Access Compliance Report

Public Rights-of-Way

(Pedestrian Signals)

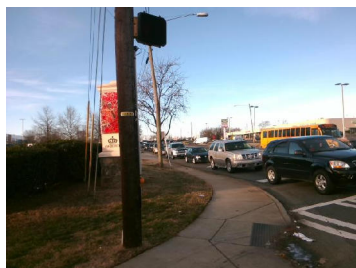
N/A	B 1 Clear Xing Direction?	Yes	N/A	B 2 Clear Xing Direction?	N/A
	B 1 Crossing Direction	To NW		B 2 Crossing Direction	N/A
No	B 1 DistanceTo XWalk (in)	151.0	N/A	B 2 DistanceTo XWalk (in)	N/A
No	B 1 DistanceTo Curb (in)	83.0	N/A	B 2 DistanceTo Curb (in)	N/A
Yes	B 1 Diameter (in)	2.0	N/A	B 2 Diameter (in)	N/A

Is Button 1 APS or Non-APS?	NonAPS	Is Button 2 APS or Non-APS?	N/A
N/A B 1 VibroTact Arrow?	N/A	N/A B 2 VibroTact Arrow?	N/A
N/A B 1 VibroTact Parallel to Xing?	N/A	N/A B 2 VibroTact Parallel to Xing?	N/A
N/A B 1 VibroTact Contrast	N/A	N/A B 2 VibroTact Contrast	N/A
N/A B 1 Pilot Light?	N/A	N/A B 2 Pilot Light?	N/A
N/A B 1 Pilot Light Illumination?	N/A	N/A B 2 Pilot Light Illumination?	N/A
N/A B 1 Verbal Walk Cycle?	N/A	N/A B 2 Verbal Walk Cycle?	N/A
N/A B 1 Verbal Message Audible?	N/A	N/A B 2 Verbal Message Audible?	N/A
N/A B 1 Locator Tone?	N/A	N/A B 2 Locator Tone?	N/A
N/A B 1 Percussive Walk Cycle?	N/A	N/A B 2 Percussive Walk Cycle?	N/A
N/A B 1 Extended Press Feature?	N/A	N/A B 2 Extended Press Feature?	N/A
N/A B 1 Tone Audible Range?	N/A	N/A B 2 Tone Audible Range?	N/A

Possible Solutions: Replace Signal Push Button With APS Button on New Post. Remove & Relocate Sign.
